SEWAGE DISPOSAL SYSTEM

DEPARTMENT OF HEALTH AND MENTAL HYGIENE

SUBDIVISION Woodford's Grant LOT 12 ROAD 11346 Barley Field Way

11346
Barley Field
Way
Lot 12

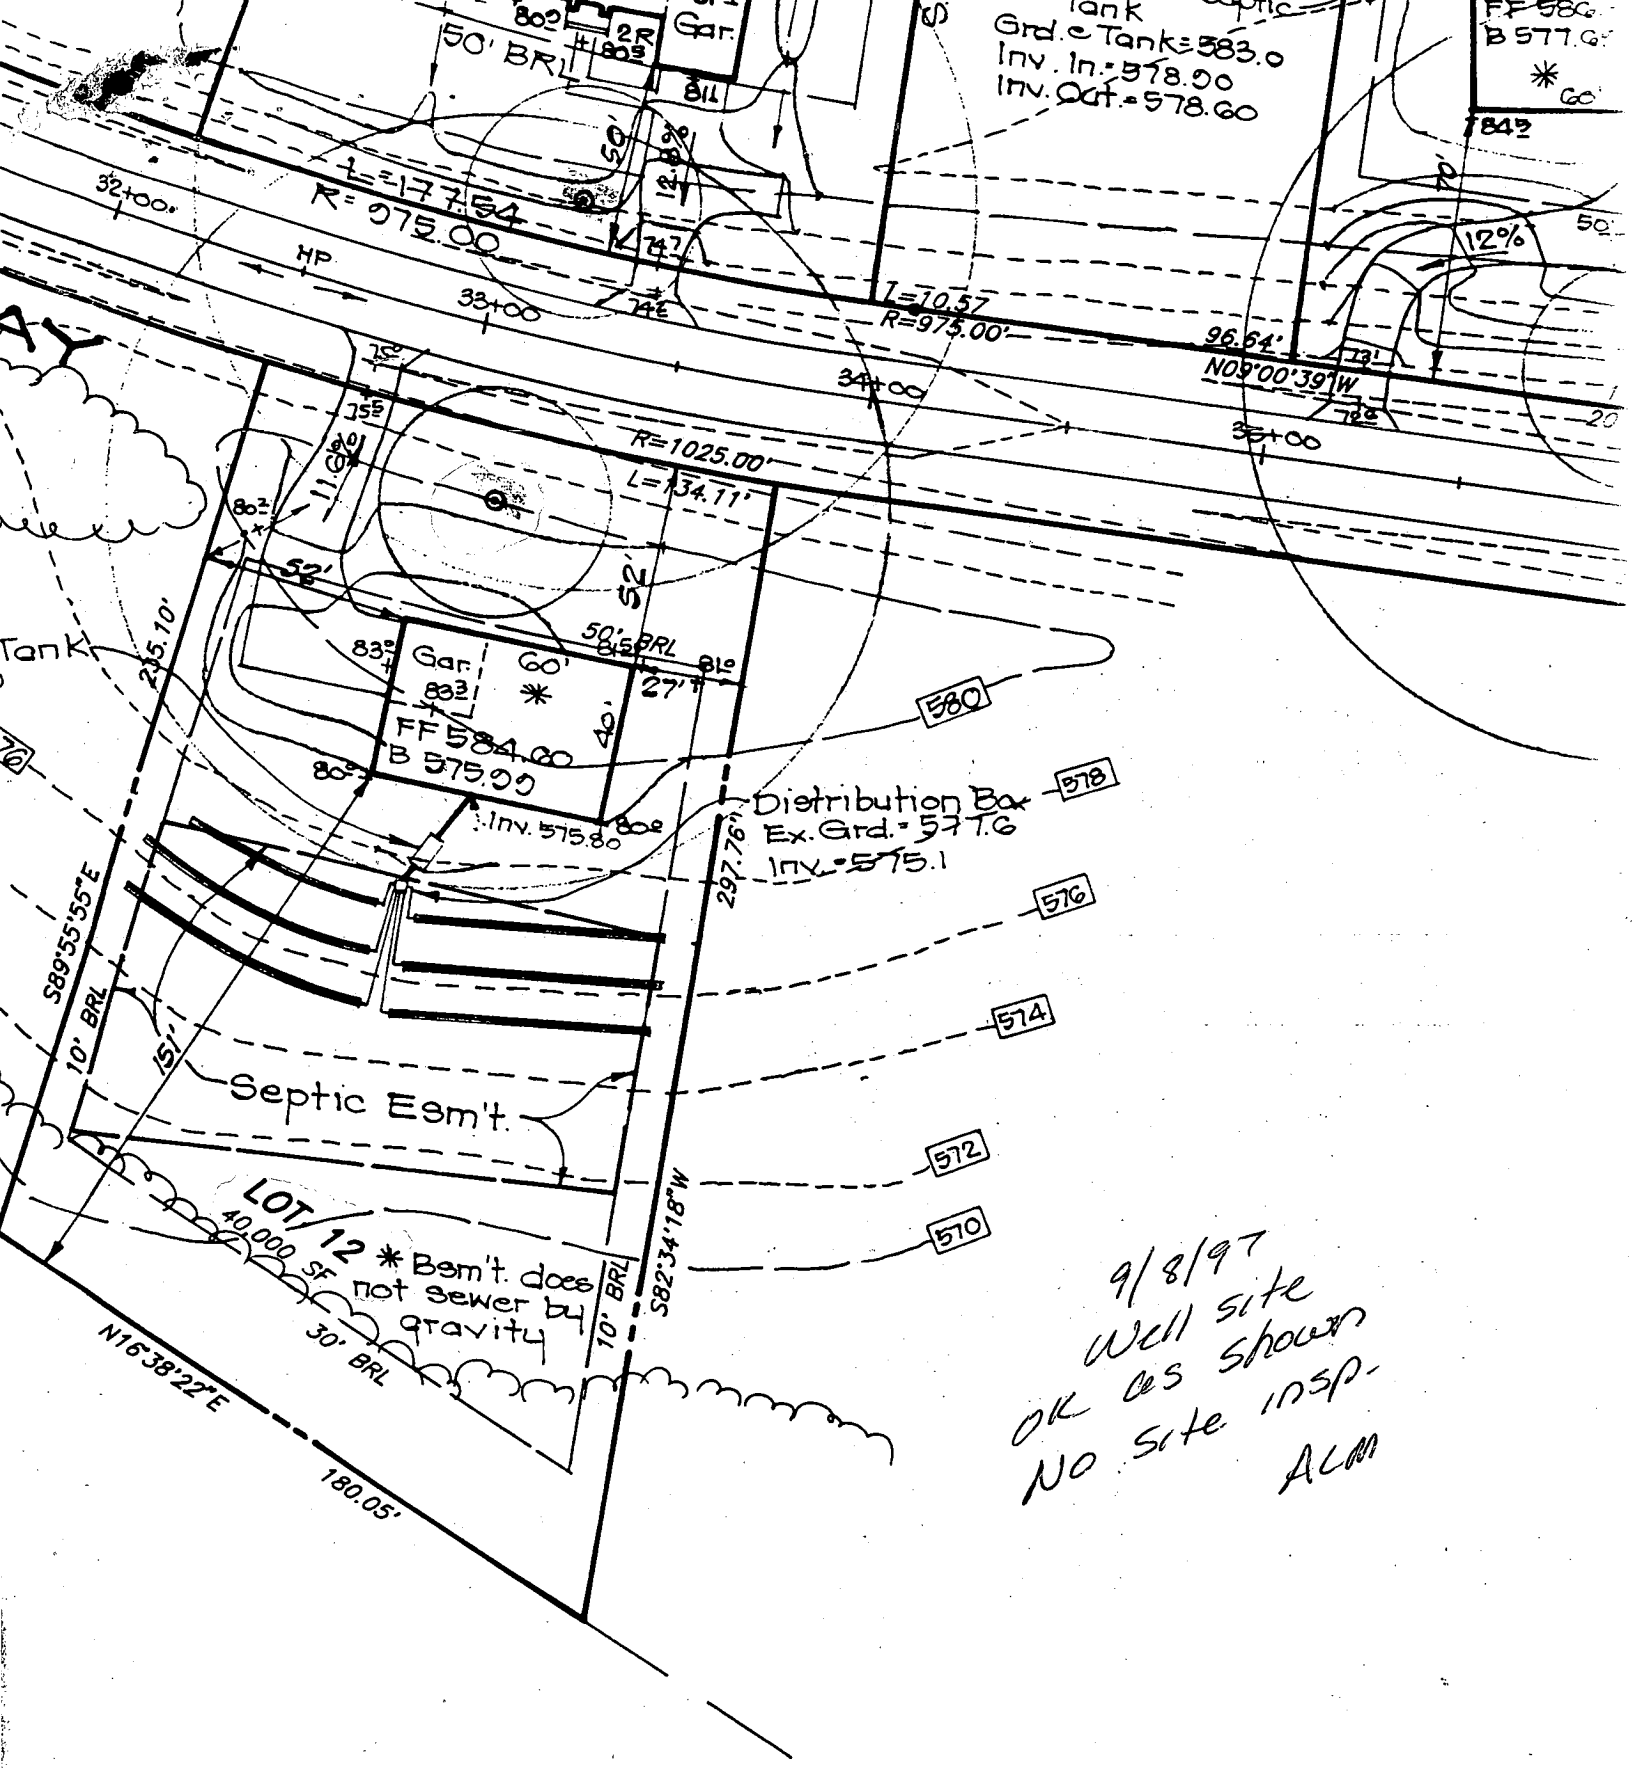
9/8/97
 Well site
 OK as shown
 No site insp.
 ALM

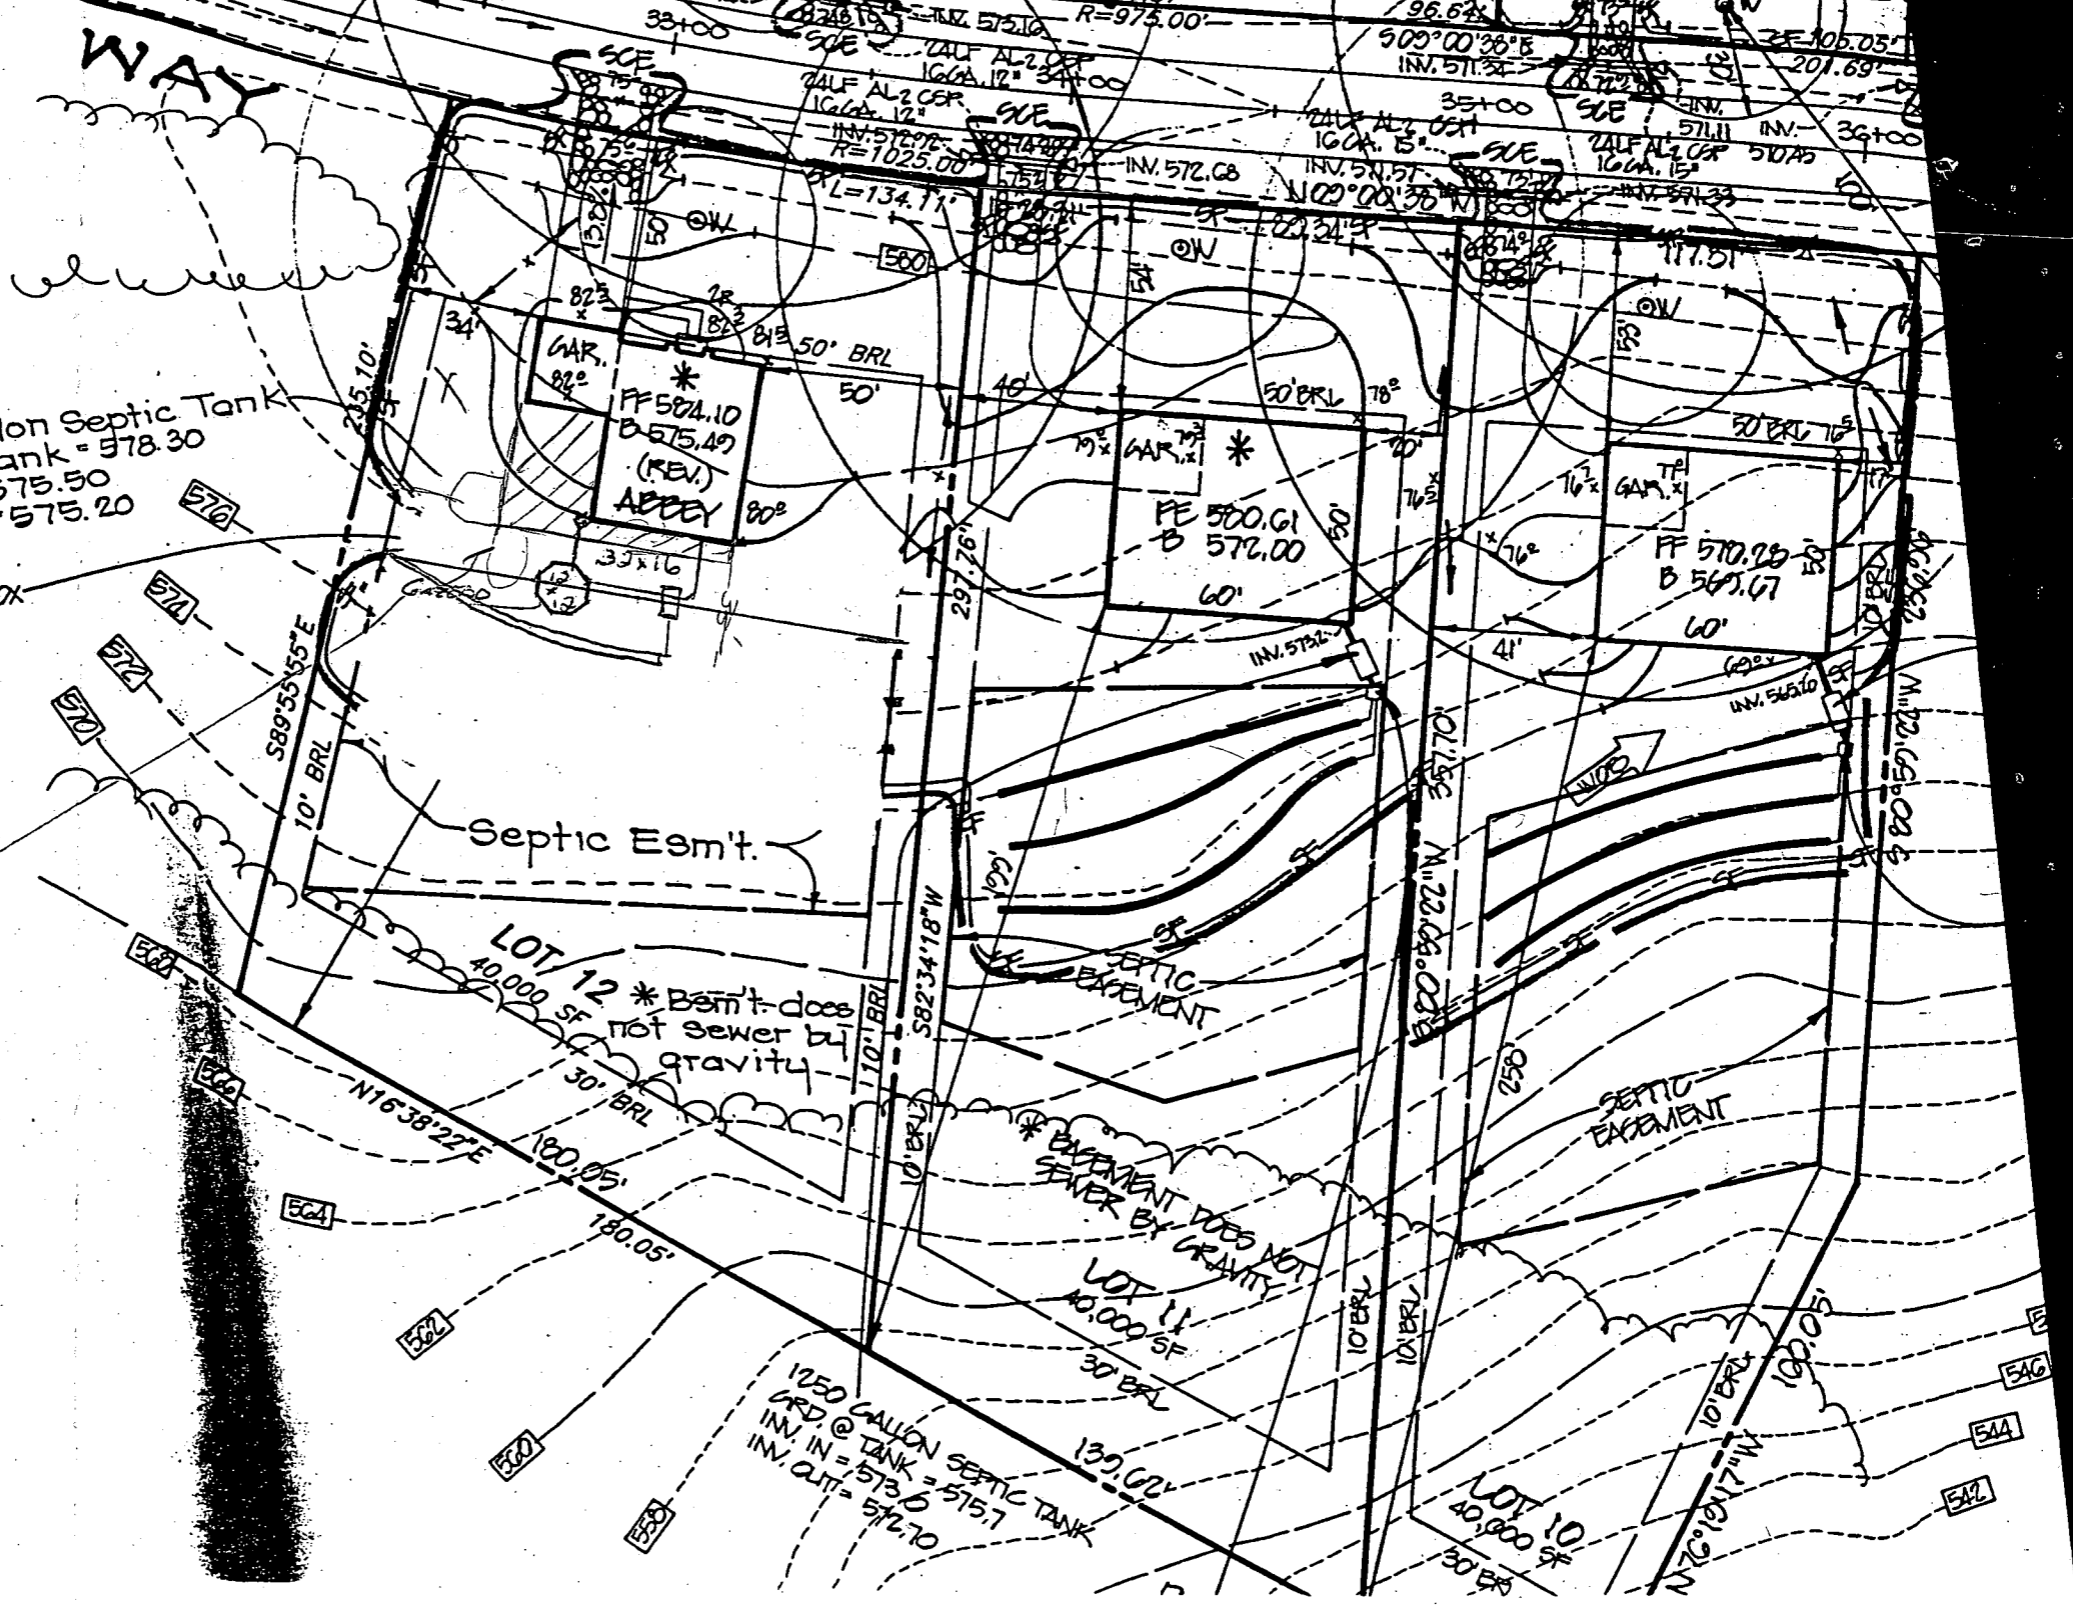
REMARKS: 12/22/97 OK to cover all work final. Although approved BP Plan shows ST. <100' from well - actual locations on-site maintain 100' separation ALM 1-13-97 spoke w/ builder (Michael Phaf) about restrictions on deck due to tank location - max 4' wide deck) he acknowledged & proposed landing to deck to allow use of french doors above S.T. see --- above for proposal ALM

Builder Deck Proposed
Deck too close to
tank & drain fields
after

Eliminated
that part of deck
near truck
& replaced w/ landscaping.

Gazebo 19' from
Drain Field
& 24' from
truck
Lattice
Screens

PROPOSAL
ACCEPTED
AS PER
APPLICANT'S
REVISIONS
DESCRIBED
DIMENSIONS
6/10/99
Craig Miller
How Co HEALTH

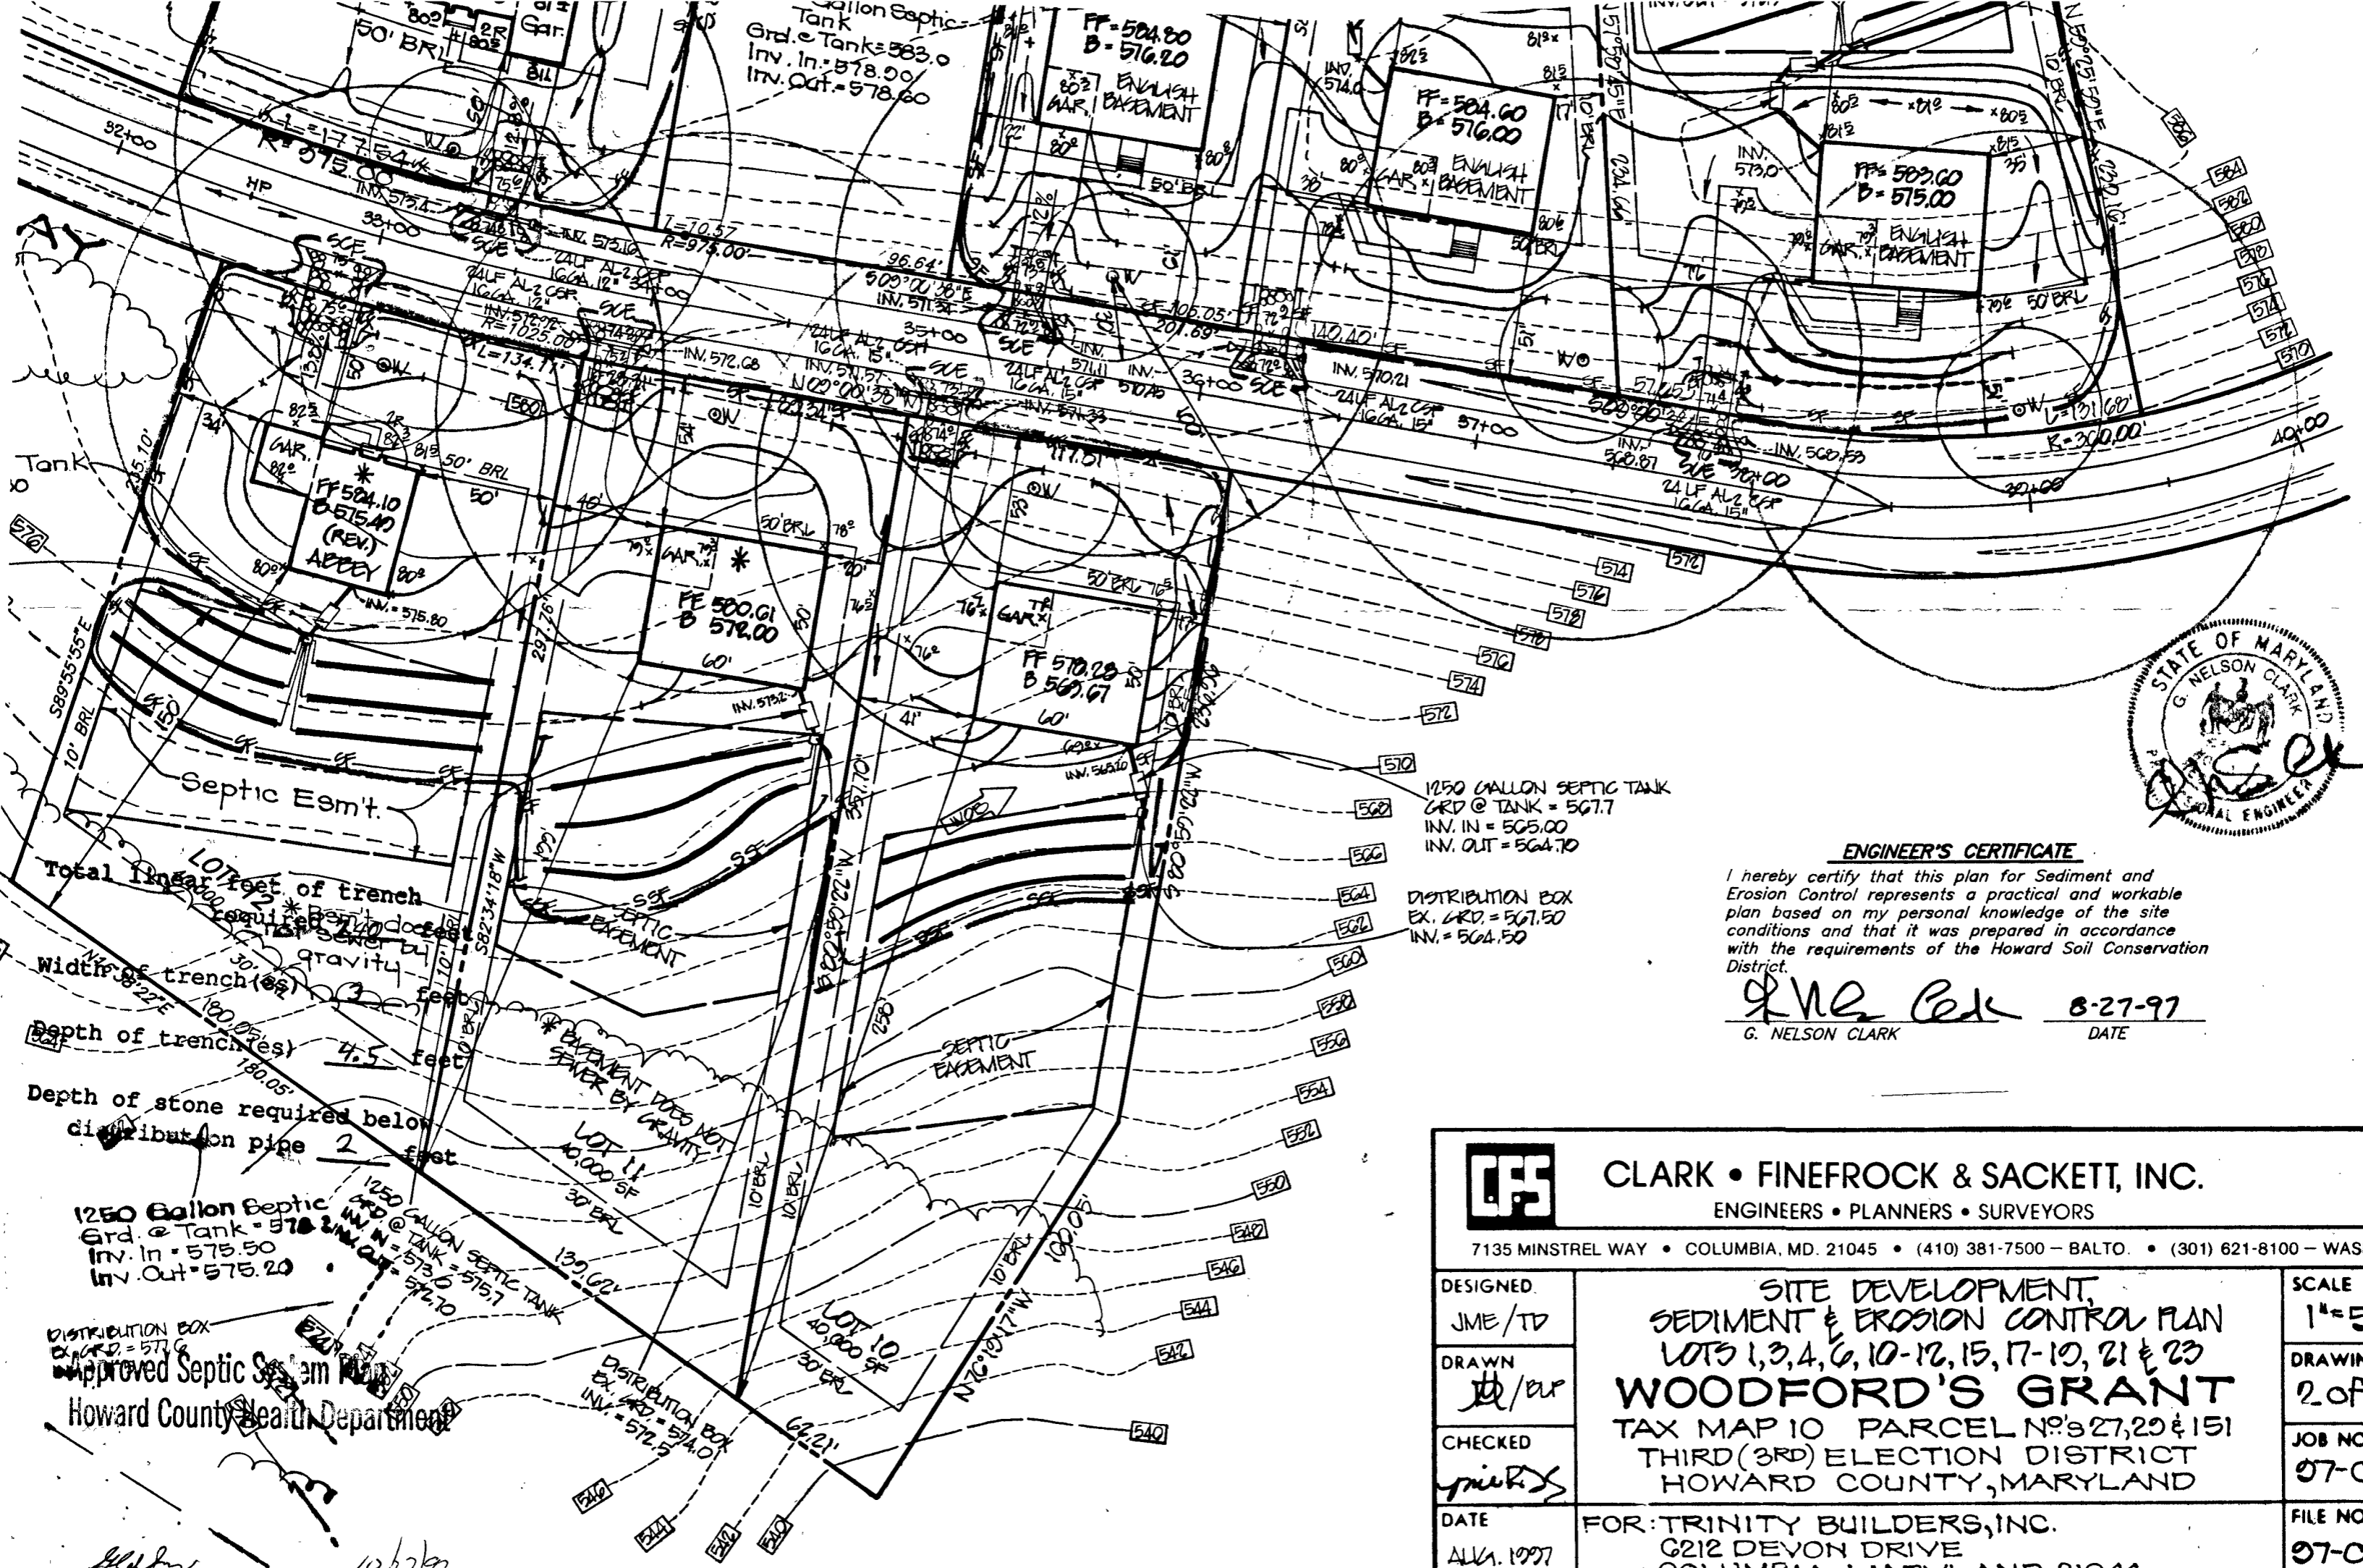
PROPOSED
TRUCK

DECK
w/ TREX
